2  
3 **Resolution adopting findings under the California Environmental Quality Act related to**  
4 **modifications to the San Francisco Public Utilities Commission Water System**  
5 **Improvement Program Calaveras Dam Replacement Project, located in Alameda and**  
6 **Santa Clara Counties, including the adoption of a mitigation monitoring and reporting**  
7 **program and a statement of overriding considerations; and directing the Clerk of the**  
8 **Board of Supervisors to notify the Controller of this action.**

# SAN FRANCISCO PLANNING DEPARTMENT

*Addendum Date:* December 13, 2012  
*Case No.:* 2005.0161E  
*Project Title:* Calaveras Dam Replacement Project  
*EIR:* 2005.0161E, certified January 27, 2011  
*Project Sponsor:* San Francisco Public Utilities Commission  
*Lead Agency:* San Francisco Planning Department  
*Staff Contact:* Chris Kern – (415) 575-9037  
chris.kern@sfgov.org

**Figure 1**  
Cross-Section of the Left Abutment

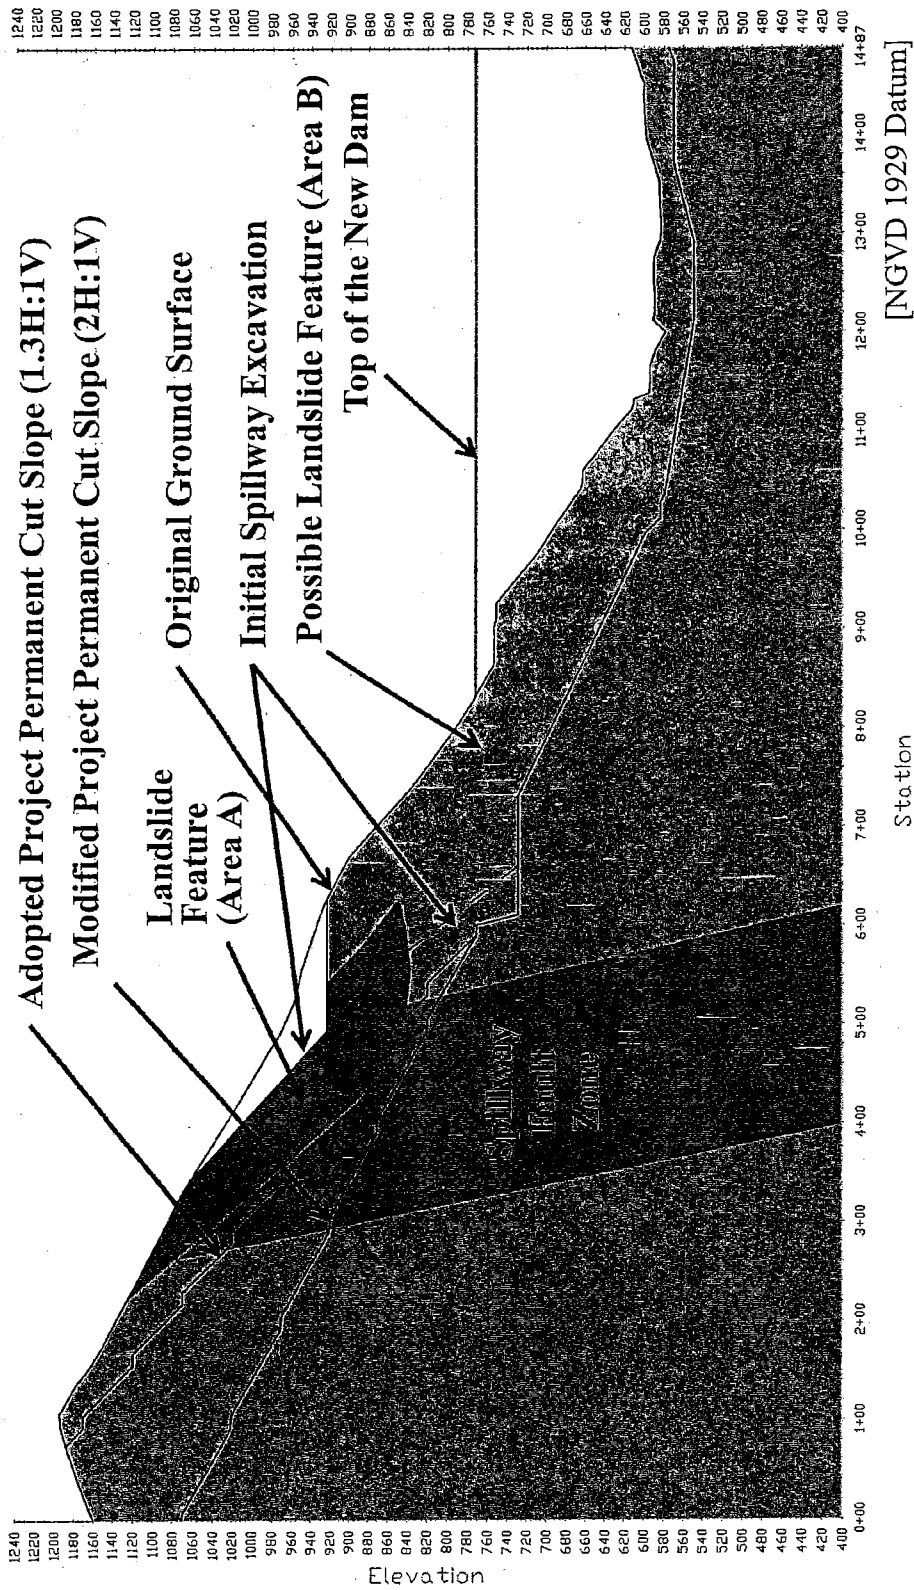
To address the newly discovered landslide hazard, the SFPUC proposed to layback (flatten) the left dam abutment in Observation Hill from the originally designed 1.3:1 slope to an overall slope of 2:1. As documented in Minor Project Modification (MPM) No. 18, on June 25, 2012, the Planning Department reviewed this proposed project modification and concurred with the SFPUC's determination that the proposal to layback the left dam abutment slope from 1.3:1 to 2:1 would not deviate from the adopted project such that it would result in any new significant impacts beyond those identified in the EIR or substantially increase the severity of a significant impact, and that no new mitigation measures would be required (see Appendix A).

In July 2012, the SFPUC initiated a geological and geotechnical study<sup>5</sup> to further evaluate the slope instability hazard affecting the left dam abutment excavation. The study found the presence of one landslide feature (Area A) and another possible landslide feature (Area B) in the spillway cut slope in Observation Hill (see Figure 1). The study also found that the Spillway Fault Zone, a zone of sheared and broken rock along the trace of the Spillway Fault, was much wider than originally considered during design. Due to the presence of the Area A landslide feature and the wider Spillway Fault Zone, the study recommended additional excavation of the left abutment and grading of Observation Hill from its original design slope of 1.3:1 to a less steep 2:1 slope as described under MPM No. 18 (see Figure 1).

Under the proposed project modifications, the SFPUC would grade the slope of Observation Hill for the spillway to an overall final slope of 2:1. The excavation of the left dam abutment slope would expand the excavation work area at the top of the slope by approximately 4.1 acres compared to the adopted project, and would be constructed between an elevation of approximately 756 feet and 1,100 feet (see **Figure 3**). The finished grade of the left dam abutment would generally consist of 12.5-foot-wide benches at 50-foot vertical intervals with slopes of 1.5:1 between benches. One of the benches, at elevation 820 feet, would have a width of 25 feet to facilitate installation of a line of 3-foot-diameter stabilization shafts up to 70 feet deep. Where needed, rock netting, rock bolts, and/or shotcrete would be placed for stabilization of the surface of the slope. The additional material to be removed and permanently disposed of by altering the 1.3:1 slope under the adopted project to a 2:1 slope proposed under the modified project would be 1.3 million cubic yards. In addition to excavating and re-grading the left dam abutment slope, an additional 410,000 cubic yards of material related to the unexpected geological features in the dam foundation is expected to require removal. This would result in a total of 1.71 million cubic yards of additional excavation and permanent disposal compared to the adopted project. The left dam abutment work also would require excavation and temporary stockpiling of an additional 1.4 million cubic yards of material compared to the adopted project. This material would be stockpiled temporarily at Disposal Site A/D until it is needed for construction of the dam foundation.
